UNITED STATES PATENT AND TRADEMARK OFFICE

APPLICATION NO.	FILING DATE	FIRST NAMED INVENTOR	ATTORNEY DOCKET NO.	CONFIRMATION NO.
09/670,820	09/28/2000	Atsushi Shimonaka	0717-0446P	8768

Office Action Summary

DETAILED ACTION

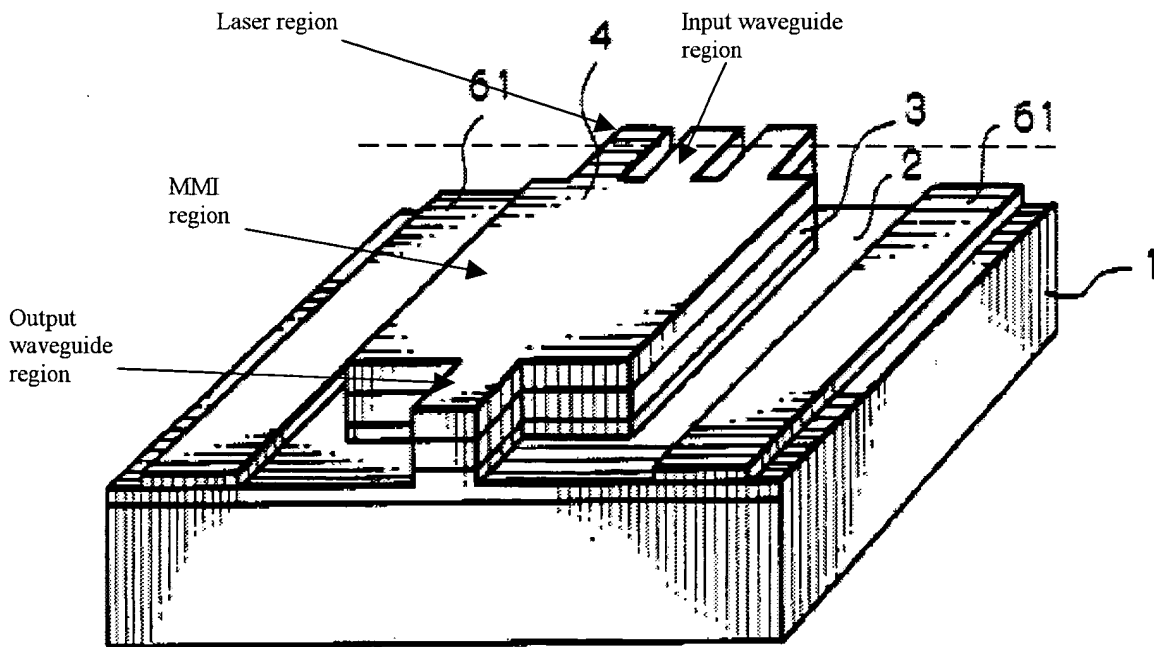
In regards to claim 1, Figures 6 and 8 of Hamamoto disclose a semiconductor laser element, comprising: a semiconductor laser region including a plurality of laser emission portions (the three protruding portions at the top of Figure 6) each having the same construction relative to one another and arranged side by side in a parallel array, each of said laser emission portions including an active layer 3 for emitting light; a multimode interference (MMI) region (middle region) including a first wave guiding layer 3; an input waveguide region located between the semiconductor laser region and the multimode interference region, said input waveguide region including a plurality of wave-guiding portions (the three protruding portions) where all the wave-guiding portions are equal length in an optical direction; and an output waveguide region (single protruding portion at the bottom of Figure 6) including a second wave-guiding layer 3, the second wave-guiding layer being optically coupled to an opposite end of the first wave-guiding layer of the interference region. As can be seen from Figures 4 and 5, Hamamoto discloses that the entire device is made from the same layers. Layer 3 functions as both an active layer and a waveguide layer. Furthermore, an electrode 7 covers all sections. Therefore, the three protruding portions at the top, the MMI region, and the single protruding portion at the bottom can be considered both laser regions and waveguide regions. Applicant has not claimed any structural difference between the laser region (laser emission portions) and the

input waveguide region (wave-guiding portions). Therefore, it is considered by the Examiner that the top halves of the three protruding portions are the laser emission portions while the bottom halves are the wave-guiding portions. The following figure is provided for clarification. The dotted line represents the junction between the laser region and the input waveguide region.
